# **FIAT SERVICE LETTER**

SUBJECT: WINDSHIELD WIPER MOTOR  
VEHICLES: 124 SEDAN & STATION WAGON (1969/70/71)

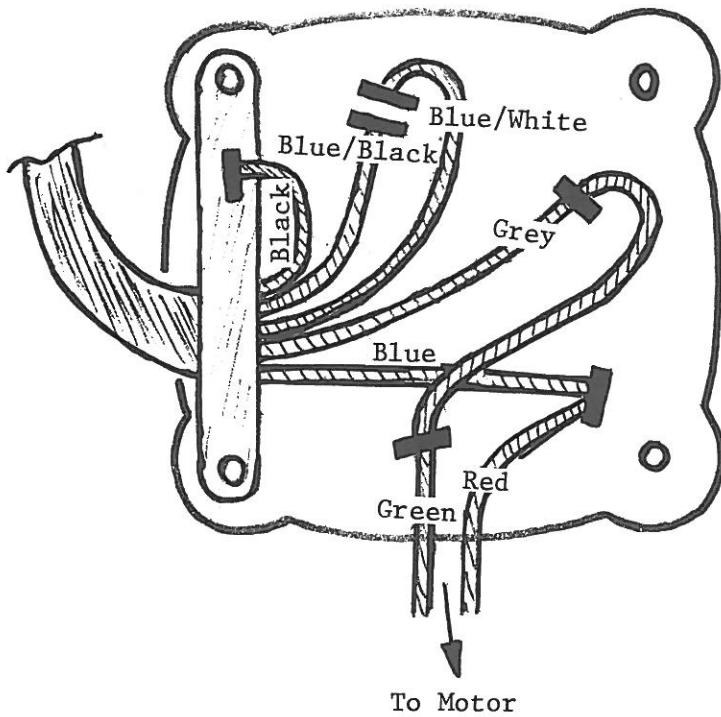
In case the wiper motor, part #9919422, is unavailable, use part #99224489, and reroute the wiring on the plate, as per the attached diagram.

Windshield wiper motor  
part #9924489 for 1972  
124 Sedan and Station  
Wagon.

Windshield wiper motor  
part #9924489 with modified  
wiring in order to fit the  
1969, 70, & 71 124 Sedan  
and Station Wagon.
